Strathfield Independent Hearing and Assessment Panel Meeting

Thursday, 7 September 2017

REPORT: SIHAP – Report No. 1

SUBJECT: 72-74 COURALLIE AVENUE, HOMEBUSH WEST - LOT 42 & 43 DP11427

Figure 3: Shadow diagram – 9:00am 21 June (Winter solstice).

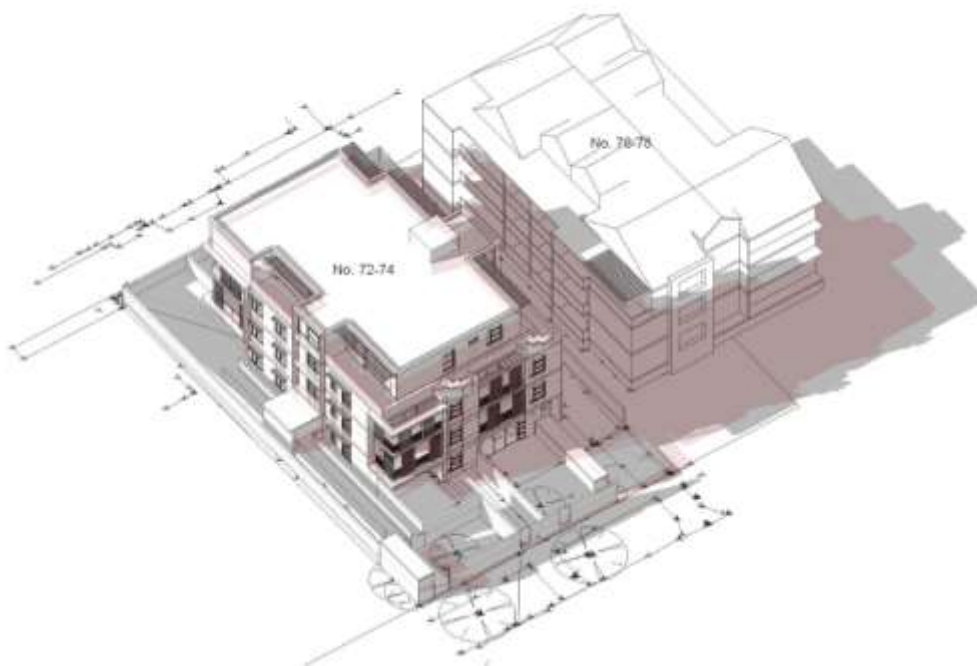
At 9am, the proposal casts the greatest shadow to the south-west, affecting the majority of north facing balconies to the first, second and third storey of the adjoining southern development. This degree of overshadowing is largely unavoidable as a result of the orientation of the land and scale of development permitted by the height and FSR controls. When compared to a compliant scheme, the proposed development results in the same degree of overshadowing to the northern elevation of the adjoining structure (Refer Figure 3.)

Figure 4: Shadow diagram – 12:00pm 21 June (Winter solstice).

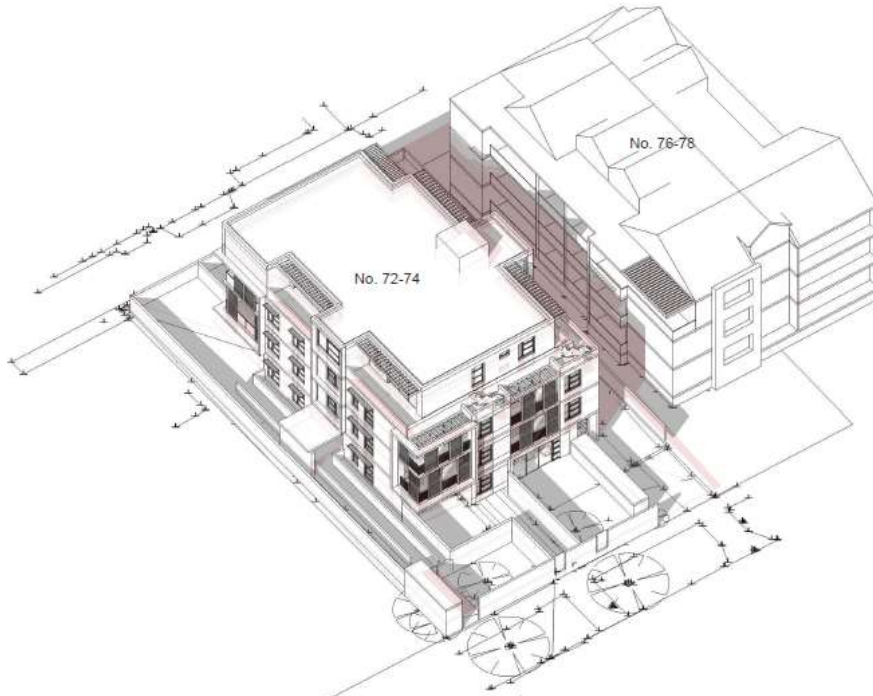
By noon, the shadow has moved to the south and continues to overshadow the first and second storey north facing balconies of the adjoining southern development. All third and fourth storey unit balconies however, now receive solar access (Refer Figure 4).

Figure 5: Shadow diagram – 3:00pm 21 June (Winter solstice).

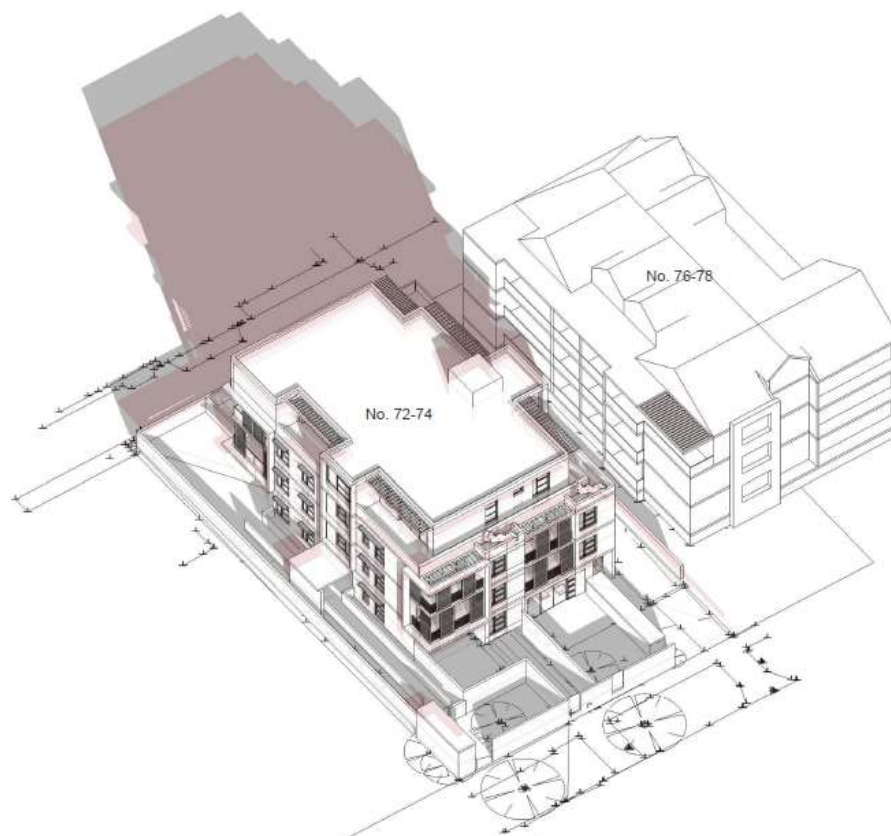
By 3pm, the shadow has moved to the east and now overshadows a number of balconies and windows on the adjoining rear property at Nos. 67-72 Marlborough Road. The overshadowing to the adjoining southern property has lessened significantly with all balconies receiving generally unobstructed solar access (Refer Figure 5).

As indicated above, the proposal results in a degree of unavoidable overshadowing to the south due of the orientation of the land. Notwithstanding this, if a conservative approach is taken, the adjoining southern property will continue to receive between 1-2 hours of solar access to north facing windows in the afternoon during the winter solstice. This generally accords with Part 4A of the ADG, which requires that 70% of all apartment living rooms and their private open spaces receive a minimum of 2 hours solar access between 9am and 3pm during mid-winter.

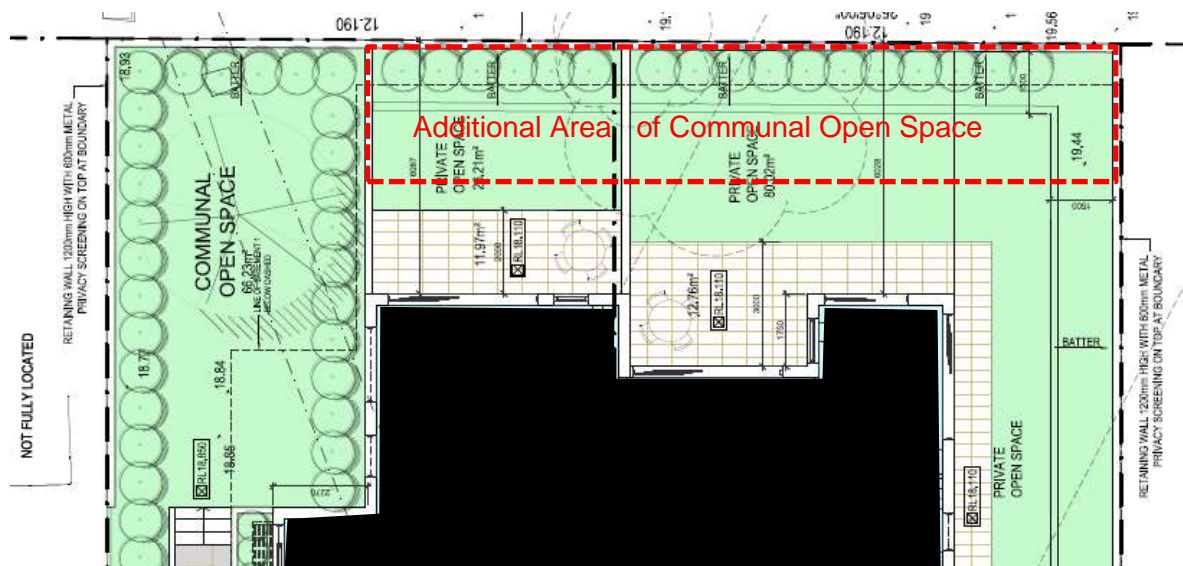
The proposal, as currently designed, provides a number of windows along both the north and south elevation that may result in overlooking and privacy impacts. As all units are provided with a dual aspect, it is recommended that a condition of consent be imposed to ensure that all windows provided along the north and south elevation between levels 1-3 be provided with either opaque glazing or highlight windows with a minimum sill height of 1.8m. Further, it is recommended that the northern elevations of balconies to unit 1.01, 1.04, 2.01, 2.04, 3.01, 3.03 be provided with fixed horizontal or vertical louvers.

In relation to the south facing ground floor windows, the proposal is suitably separated from the property boundary and will be largely concealed by the 1.8m high dividing fence to mitigate overlooking and privacy concerns. Notwithstanding this, the majority of south facing windows are to passive rooms such as bedrooms and bathrooms.

In relation to the north facing ground floor windows, the proposal is suitably distanced from the northern boundary and is adequately shielded by a 1.8m high dividing fence. Moreover, the adjoining allotments to the north are currently occupied by single residential dwelling houses, that are at a considerable distance from the proposal. Accordingly, the ground floor north facing windows raise no privacy concerns.

Figure 3: Proposed streetscape elevation

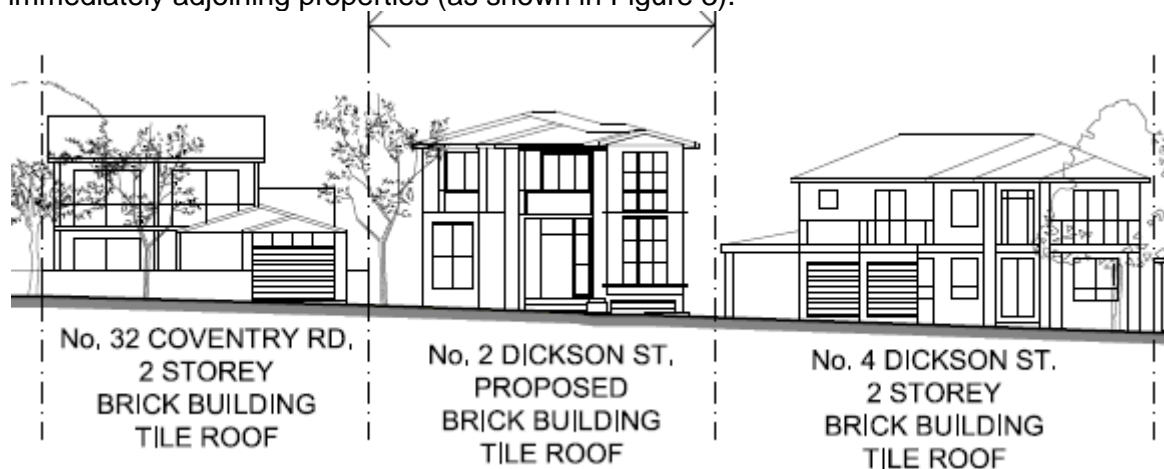
- The proposed development seeks a maximum height of 9.0m which demonstrates compliance with Clause 4.3 of the SLEP, 2012.
- The proposed height is appropriate for the gradient of the site and compatible with the immediately adjoining properties (as shown in Figure 3).

- The proposed development achieves compliance with the relevant FSR provisions applying to the site under the SLEP 2012. A mixture of single and two (2) storey dwellings are found along Dickson Street.
- As shown in Figure 3, the scale of the proposed dwelling is consistent with the eastern and western adjoining dwellings and the overall Dickson Street streetscape.
- The proposal is unlikely to adversely impact upon the amenity of adjoining properties by the imposition of the recommended conditions.
